Delegated officer report for planning application

Application no. 144158/LO/2025
Date registered valid: 11 December 2025
Proposal: Listed Building Consent for internal and external alterations.
Address: Grosvenor West - Grosvenor Building, Manchester Metropolitan University, Cavendish Street, Manchester, M15 6BG
Ward(s): Hulme Ward

The proposal seeks Listed Building Consent for internal and external alterations.

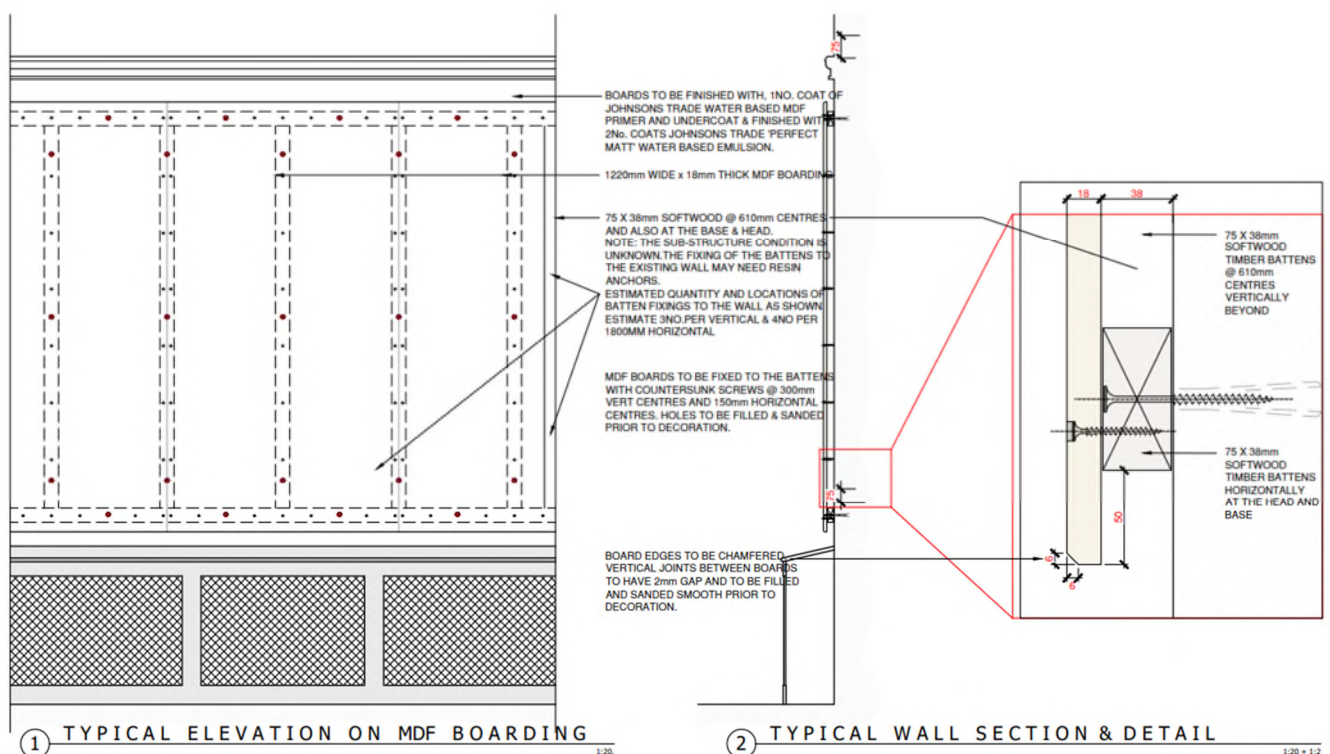
The works are required to maintain integrity of the external gables onto Cavendish Street which have cracking defects and an outward lean.

The supporting structural report by Curtins proposes several remediation measures to stabilise the movement and includes:

- Helix anchors to be installed through stone arches to limit arch leaf separation. There will be some harm from drilling through the arch but will be concealed with stone infill and not visible from the exterior. The work is considered to be proportionate to secure the structure.
- It is proposed to install metallic ties downwards from the gable coping through crack zone in stone. This element will be visually concealed and harm would be low.
- Tying of gable ends are required to roof purlins to stabilise movement. This will require angle brackets to be fixed to internal brickwork in gable wall and roof purlins. There would be some harm from bracket fixings but is negligible and offset by the need to make sure the building is safe and stabilised.

The methodologies proposed have been fully reviewed by the City Council and are supported as they are considered to be proportionate to stabilise the gable structures.

There will be a low level of less than substantial harm caused by these works.

A condition has been added to ensure that any infilling will match the existing stonework.
